Community Development Department

Date: April 24, 2017

Subject: Approval of a vendor cart to be located on McFadden Plaza at 224 S. Carson Street (Mom & Pop's Diner), pursuant to the provisions of the Carson City Municipal Code, Development Standards Division 1.11 and Downtown Mixed Use Development Standards, Division 6.6.9.

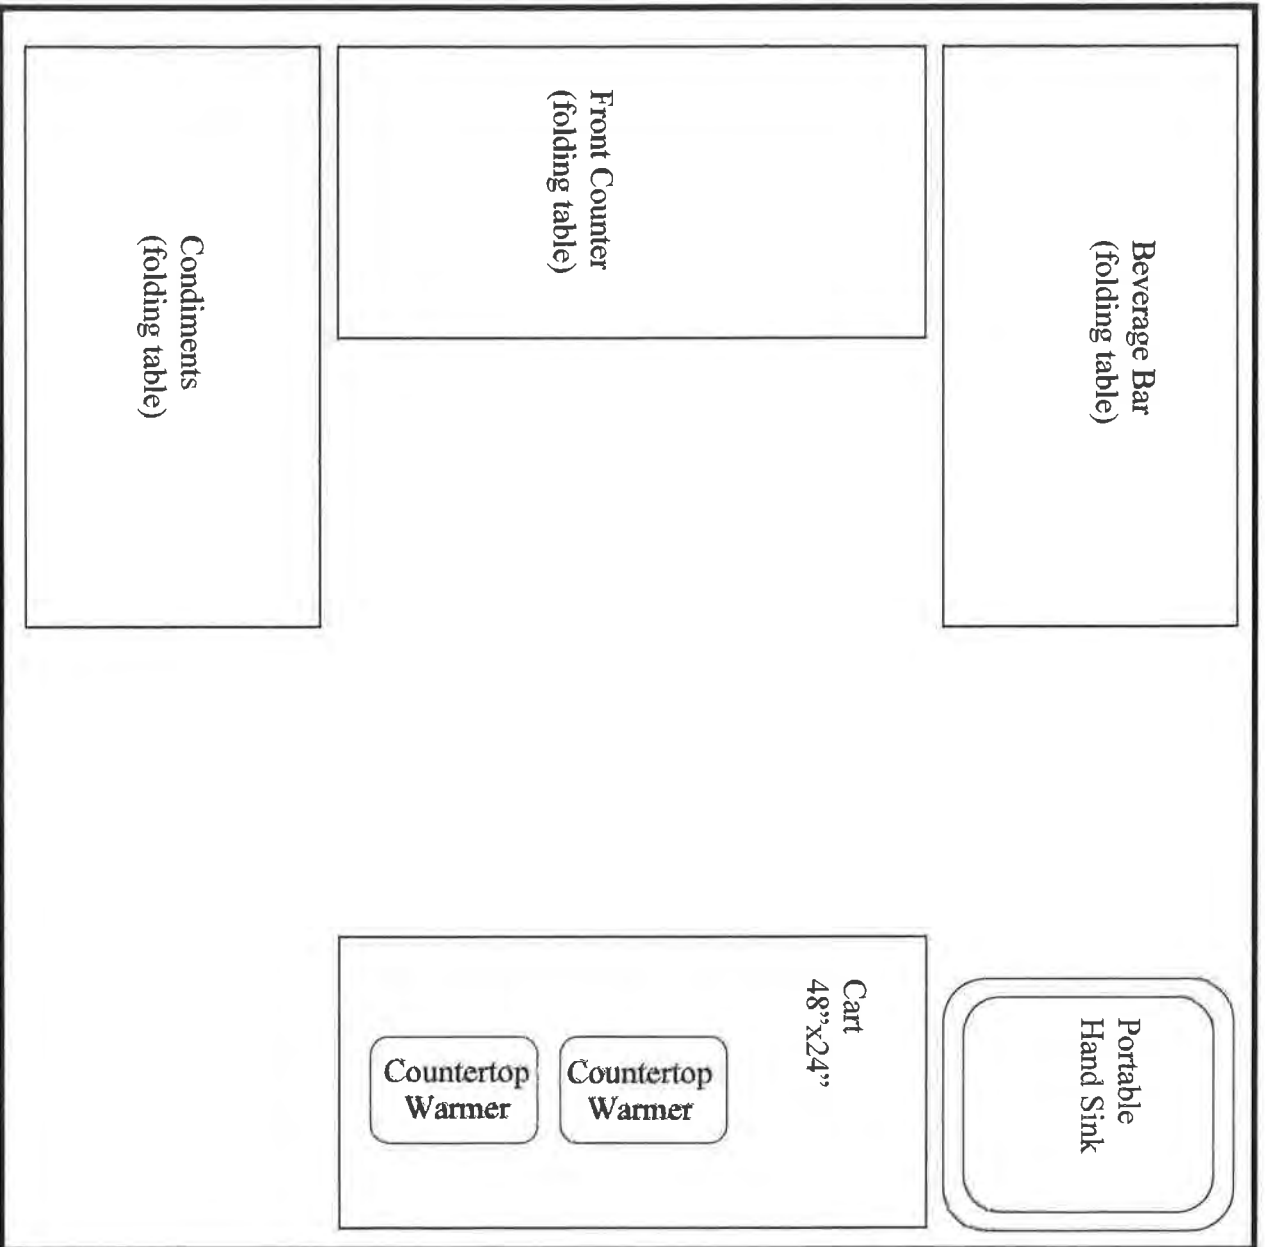
Staff comments: The applicant is requesting the vendor cart for the specific location at 224 S. Carson Street. A person may operate a vendor cart at various locations, but each location would need to be specifically approved by the RACC. This application is only for the one location.

Staff comments: The proposed vendor cart is on wheels and not larger than three feet by five feet. Additional tables are proposed to be used to serve customers and for condiments.

Staff comments: The proposed location of the vendor cart is within the City right-of-way, within McFadden Plaza. An Encroachment Permit will be required from the Public Works Department and the applicant must comply with all conditions of the Encroachment Permit. The Board of Supervisors introduced an ordinance to establish the downtown Encroachment Permit standards on April 20, 2017, and the final standards are anticipated to be adopted by the Board on May 4, 2017. The Encroachment Permit regulations require the applicant to obtain certain liability insurance in compliance with this development standard.

Staff comments: The applicant plans on connecting to an adjacent power source on the plaza. The recommended conditions of approval would require the applicant to get applicable permits and inspections for the power source. Since the power source is a public power source for events, additional requirements may be implemented by the Public Works Department through the Encroachment Permit.

1. This approval is for the vendor cart specifically located at 224 S. Carson Street at the location identified in the site plan submitted with the application to the Redevelopment Authority Citizens Committee (RACC). Use of the vendor cart at another location may only be permitted upon approval by RACC.

2. The vendor cart must be on wheels and must be no larger than three feet by five feet. Additional tables may be used for condiments and to serve customers.

6. The applicant must obtain any necessary permits and inspections from the Building Division and/or Fire Department for the electrical connection. Use of the City power
